SUTHERLAND SHIRE COUNCIL ASSESSMENT REPORT

Panel Reference	PPSSSH-118
DA Number	MA22/0137 to DA18/0323
LGA	Sutherland Shire
Proposed Development:	S4.56 modification to DA18/0323 – changes to internal layouts, parking allocations, finishes and landscaping components
Street Address:	Lots 1 to 3 S/P 9336, S/P 9336, S/P 48254, Lots 1 to 4, Lots 4 - 6 S/P 67206, S/P 67206 – 5 to 9 Ozone Street, Cronulla
Applicant/Owner:	Ozone Cronulla Pty Ltd
Date of DA lodgement	26 May 2021
Number of Submissions:	2
Recommendation:	Approval
Regional Development Criteria – Schedule 6 of the Planning Systems SEPP 2021	This application is referred to the SSPP as this application is an application made under Section 4.56 of the Environmental Planning and Assessment Act 1979 and is a modification to an application previously heard by the SSPP and approved by the Land and Environment Court. As this application is made under Section 4.56, it is required to be determined by SSPP.

Report date	15 November 2022

Figure 7: MA21/0080 approved ground floor plan (source: MA21/0080 approved plans)

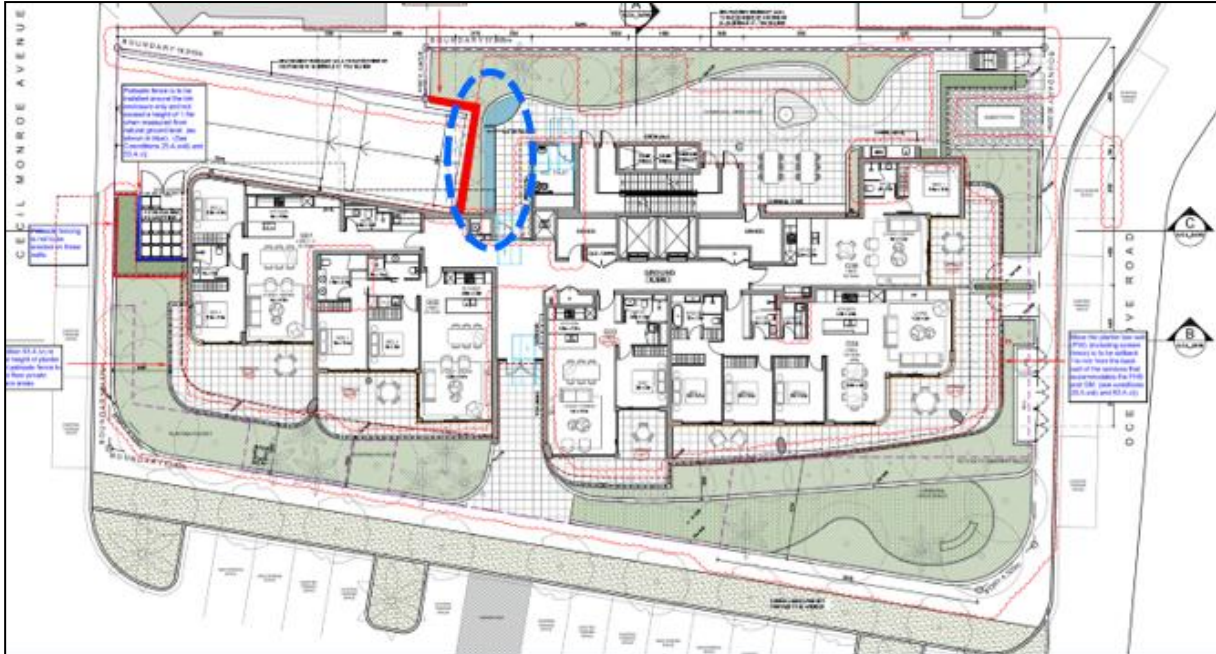
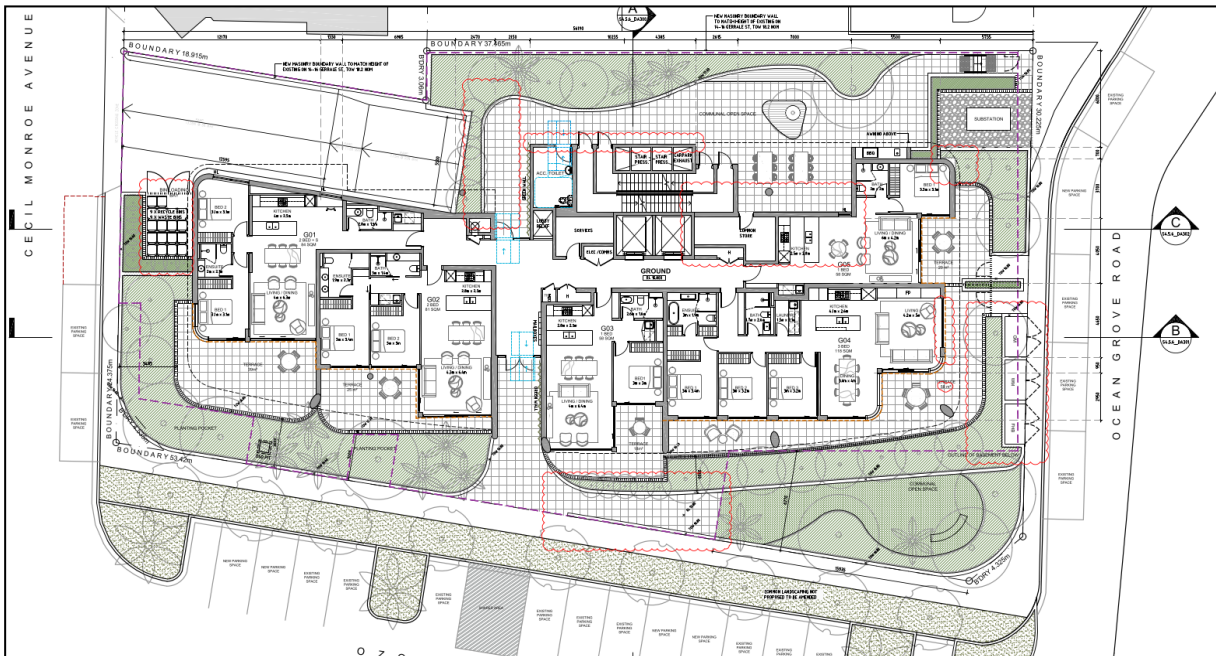
The water feature located at the south-western corner of the rear communal space (circled blue) was approved under DA18/0323 and subsequent modification applications, is proposed to be deleted by this subject modification application. The approved ground floor plan and the proposed MA22/0137 are provided below for comparison.

No objection is raised to the deletion of the water feature from the communal open space area.

Figure 11: Proposed western elevation deleting the green wall (source: Applicant's revision 1 plans)

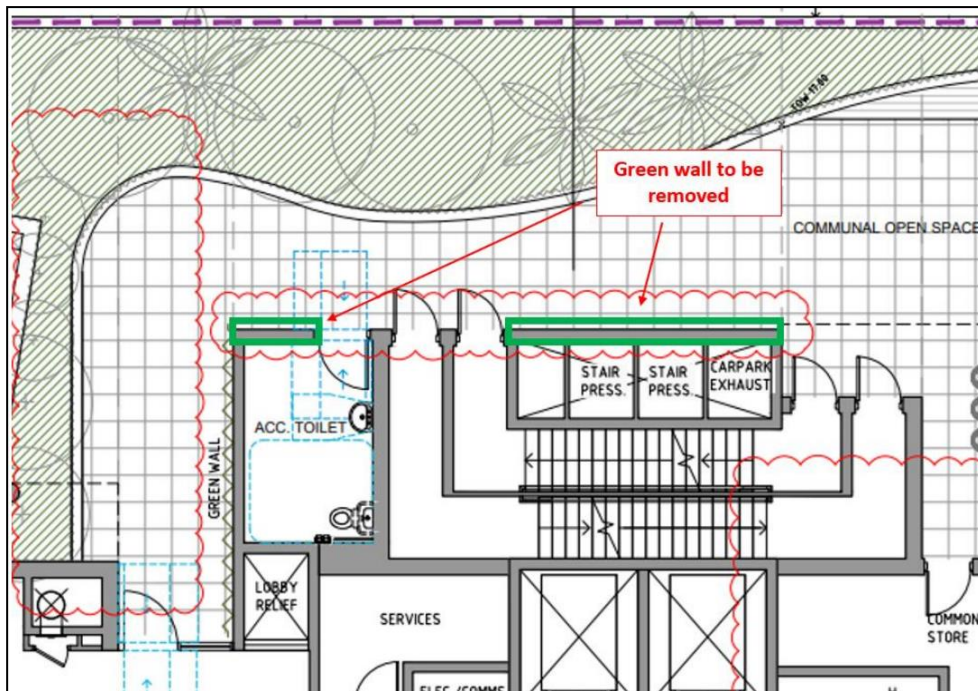
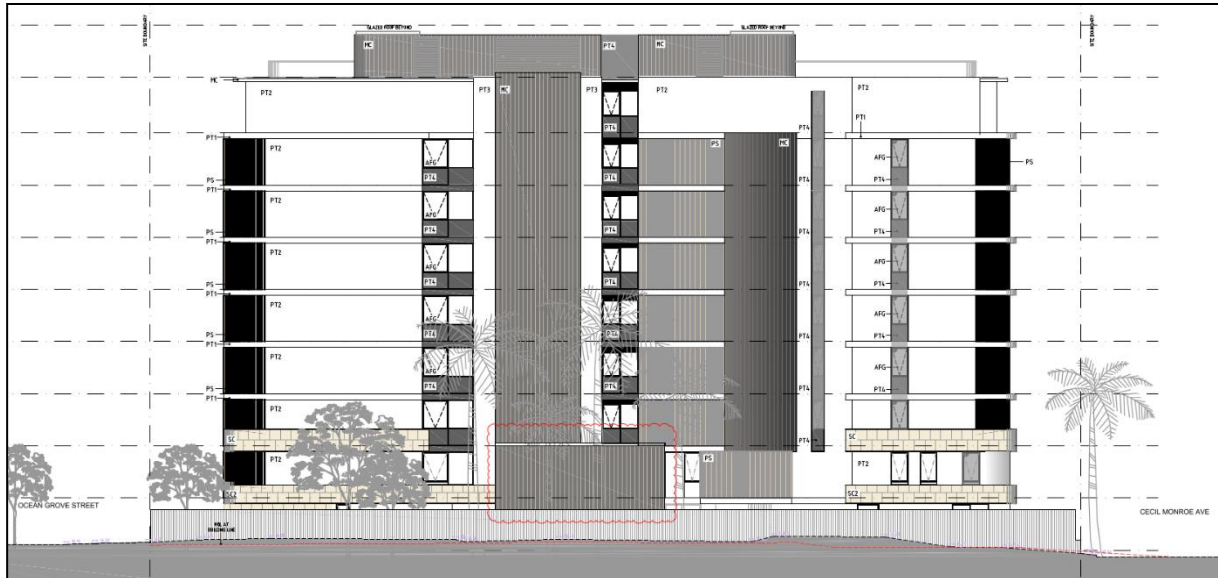
The green wall along the ground floor and first floor western façade is proposed to be removed and replaced with the surrounding western external façade material. The location of the approved green wall is shown at **Figure 9**. The removal of the green wall is intended to reduce maintenance in the future with ongoing pruning and watering a factor for the wall to be removed.

The deletion of the green wall from the western façade of the COS area is not accepted, as the green wall contributes to breaking up the bulk of the building and deleting this would decrease the quality and visual interest of the COS area. The approved green wall softens the hard surfaces of the western elevation and provides improved amenity to users of the COS as well as when viewed from the neighbouring properties at 14 and 18 Gerrale Street.

Figure 13: proposed rooftop / pool area (source: Applicant's revision 1 plans)

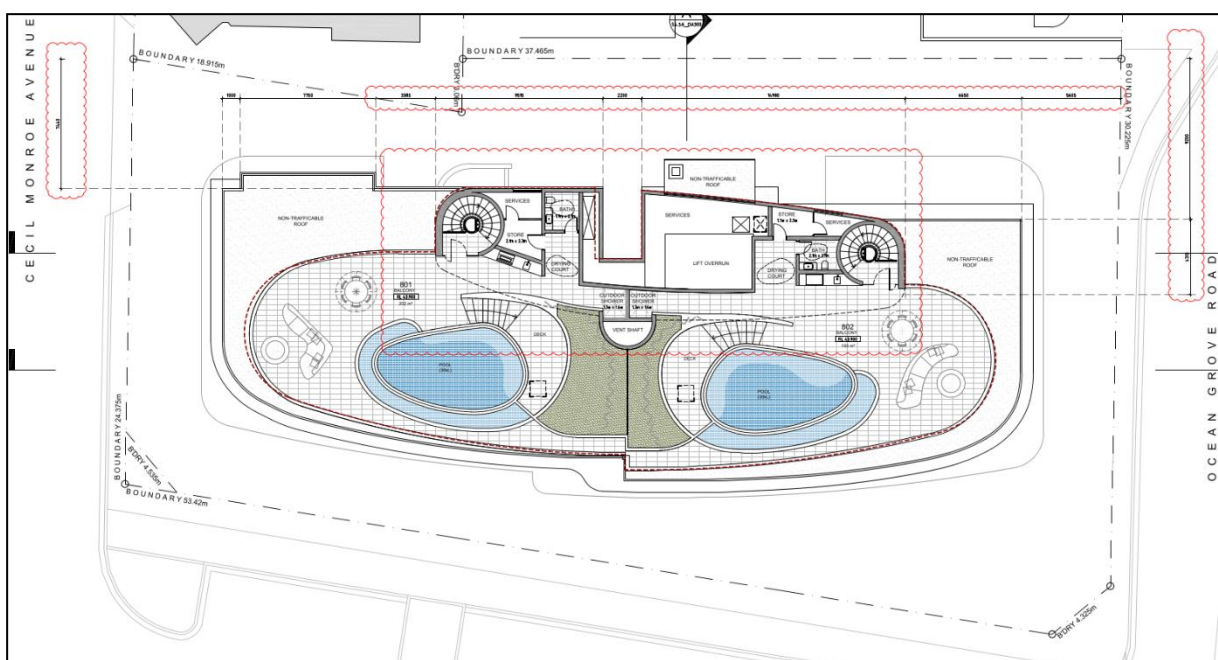
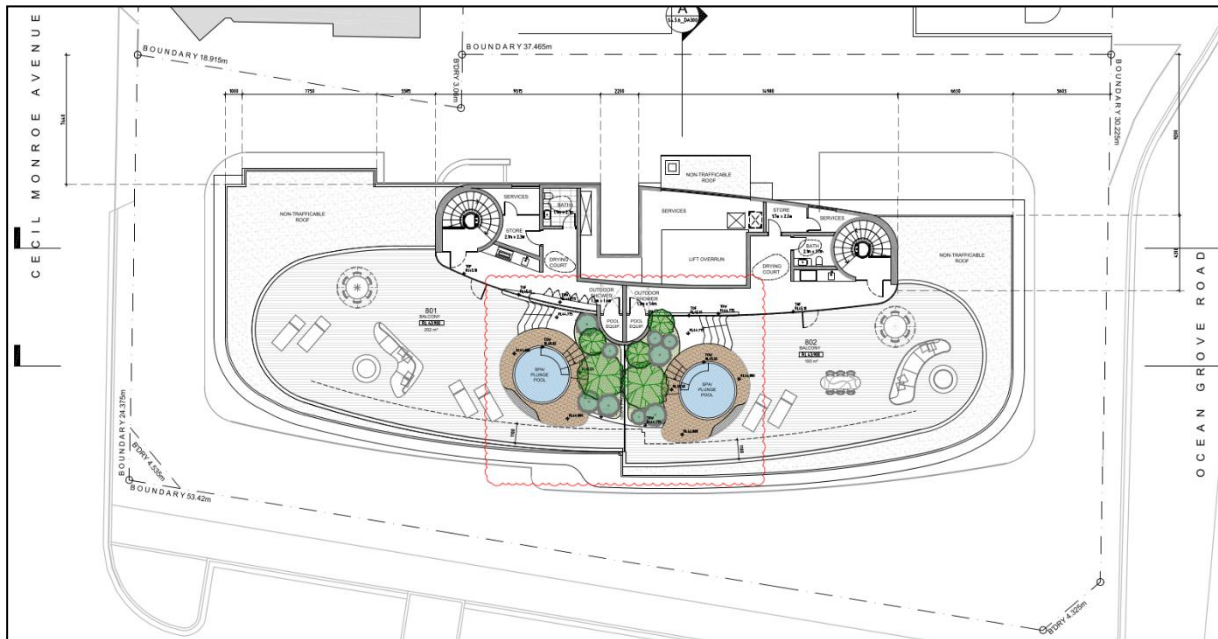
The modification application seeks to reduce the size of the two pools to minimise the structure required to support the two large pools approved in the original development consent. The proposed change introduces two spa/plunge pools opposite each other at the centre of the building, as opposed to two 30kl recreational pools. The approved pools in comparison to the proposed plunge pools are shown below at **Figure 12 – 13**.

The redesign of the two pools promotes greater connectivity along the rooftop balcony and includes the planting of trees and small shrubs to provide some natural shade on the rooftop. The reduced size of the pool also reduces the visual impact and bulk of the roof terrace features when viewed from neighbouring elevated properties. This aspect of the modification is acceptable.

Figure 15: proposed landscape treatment along the stairs (source: Applicant's revision 1 plans)

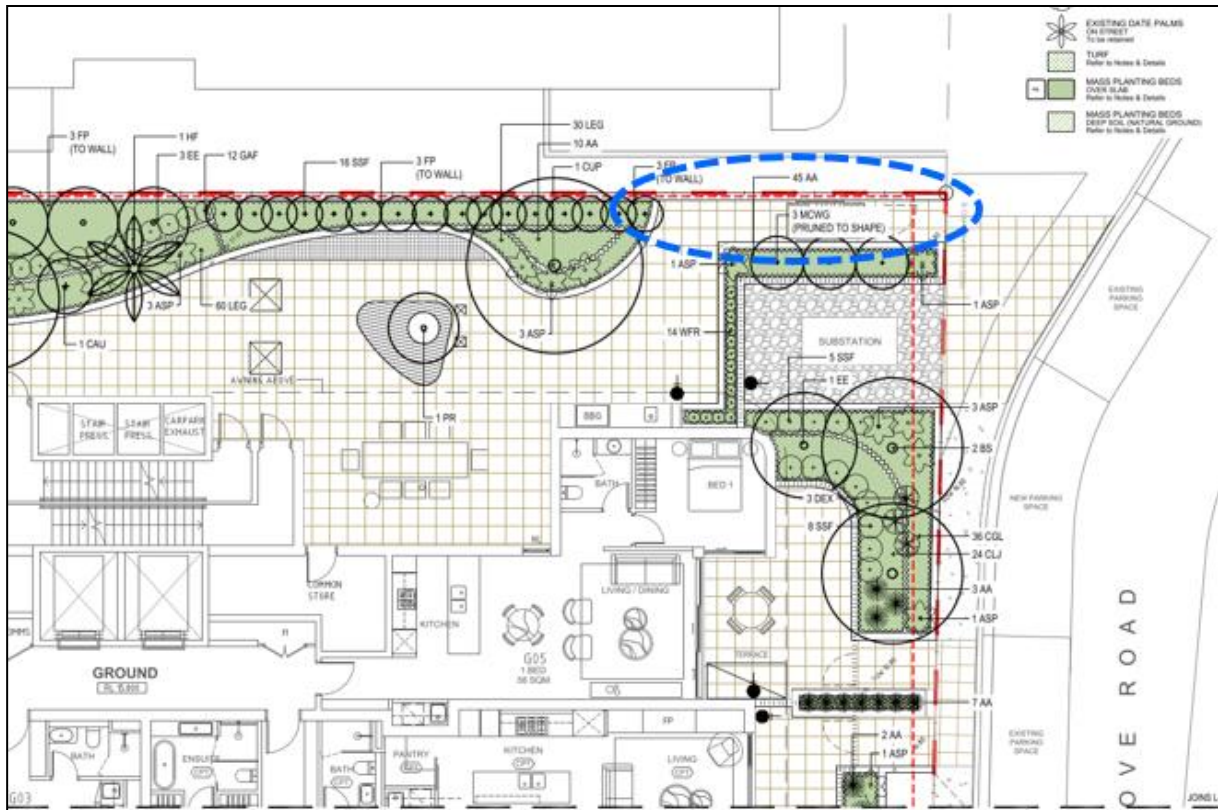
The application proposes the deletion of a narrow planter bed along the western boundary adjacent to the stair egress.. **Figure 14 – 15**, identify the location of this narrow planter bed as circled in blue.

Given the narrow width of the approved planter bed, no objection is raised to the removal of the planter bed as a planter bed will be retained adjacent to the substation that will soften the pedestrian entrance when viewed from the street. Deletion of this planter from the proposal is acceptable

Figure 17: proposed landscape treatment at Unit G03 (source: Applicant's revision 1 plans)

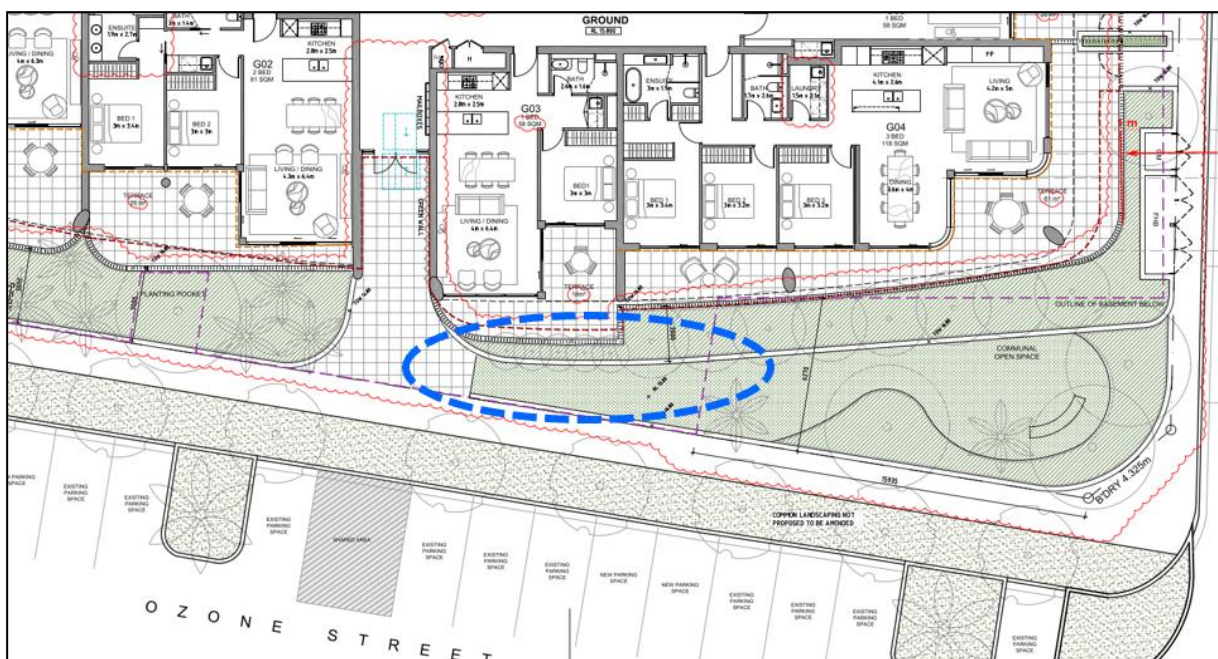
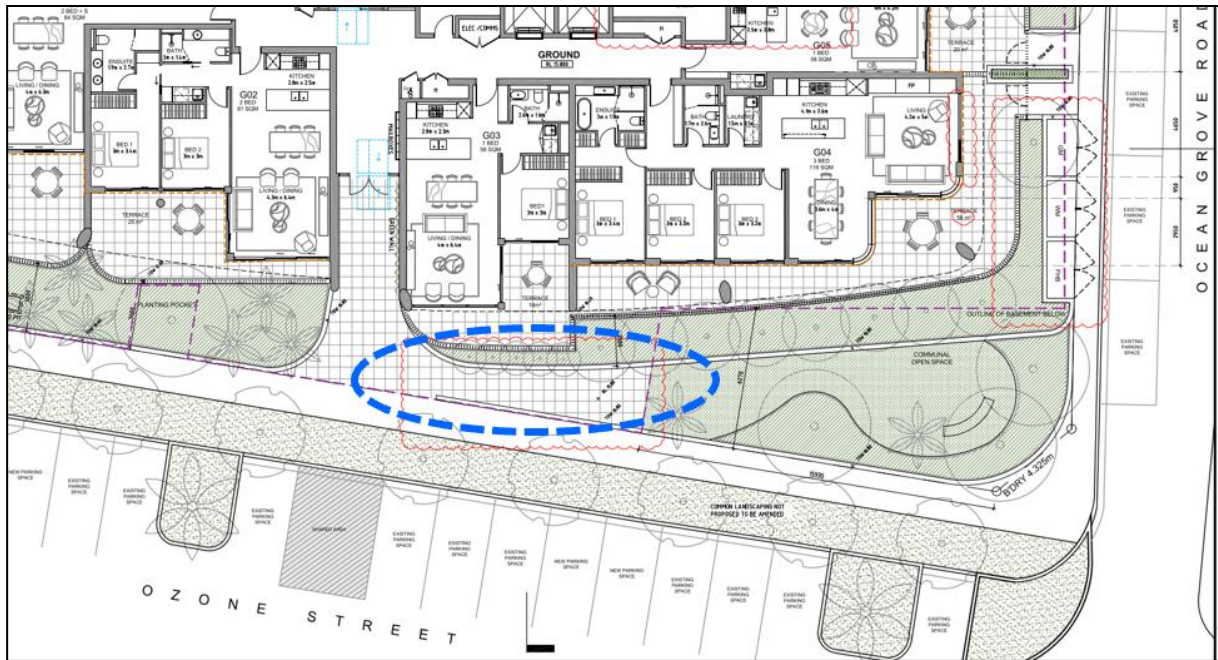
The application proposes to remove landscaping adjacent to the Unit G03 POS area, to be replaced with hard stand titles, as shown in **Figure 16 – 17**.

The modification to the landscape design would diminish the streetscape and landscaped character and would result in a harsh interface when viewed from the street and surrounding properties. This aspect of the modification is not supported and this area will remain as landscaped area as approved under MA21/0080.
